DEVELOPMENT ASSESSMENT REPORT	
<b>Application No.</b>	MOD/2022/0450
<b>Address</b>	2C Gladstone Street NEWTOWN
<b>Proposal</b>	Section 4.55 Modification to DA/2021/1188, modifications include changes to basement, unit layouts, commercial floor areas, material finishes and detailing of services to roof.
<b>Date of Lodgement</b>	16 December 2022
<b>Applicant</b>	Samcourt Pty Ltd
<b>Owner</b>	The Registered Proprietors Of SP 17149
<b>Number of Submissions</b>	Six (total)
<b>Value of works</b>	\$6,000,000
<b>Reason for determination at Planning Panel</b>	Variations exceed 10%
<b>Main Issues</b>	<ul style="list-style-type: none"> <li>• Not substantially the same development</li> <li>• Contrary to the objectives of Zone E3 – Productivity Support</li> <li>• Contrary to Section 4.4 Floor space ratio development standard</li> <li>• Internal amenity of commercial spaces</li> </ul>
<b>Recommendation</b>	Refusal

## 1. Executive Summary

## 2. Proposal

Figure 4: Approved plans – cross section and mezzanine/level 1 (GFA highlighted in blue)

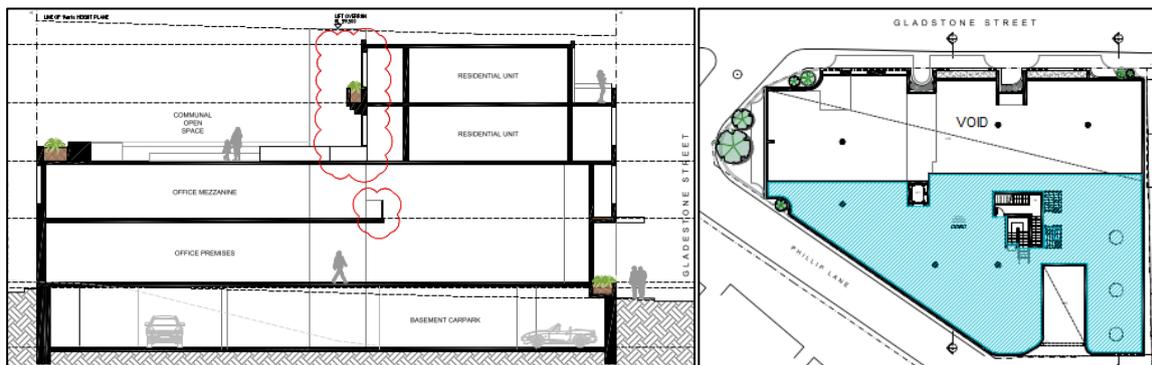
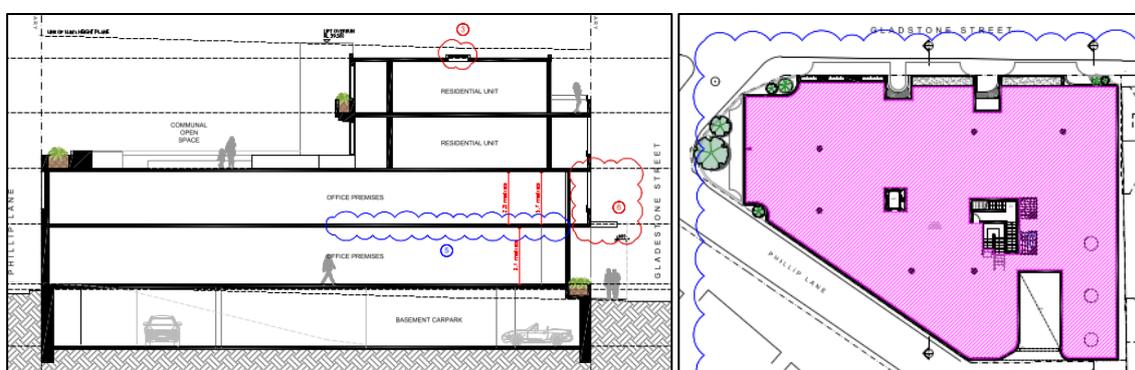
As illustrated above, the infilling of the void space results in the loss of the double height (approximately 6.2m) component of the commercial space. The double height commercial space was an important element of the original proposal as it enabled functionality and flexibility for future uses by providing an internal height that could accommodate a mix of medium to large format businesses and emerging light industries in accordance with the E3 zone objectives, discussed further below.

The modified proposal results in the entirety of the commercial space having floor to ceiling heights of 3.1m on the ground floor and 2.8m on the first floor which fails to achieve the minimum 3.3m ceiling height requirement of the Apartment Design Guide and significantly limits the nature of businesses capable of operating at the site. It appears an intent of the additional commercial floorspace is to offset the increase in apartment sizes whilst maintaining compliance with Section 6.22 of the *IWLEP 2022*, which requires not less than 60% of the total gross floor area being used for non-residential purposes.

Furthermore, the infill of the void results in a floor depth of up to 29m which is detrimental to amenity and viability of both the ground floor and first floor commercial spaces. As such, it is considered that this modification changes a significant material feature and essential component of the original consent and if proposed as part of the originally approved DA would likely have resulted in a refusal.
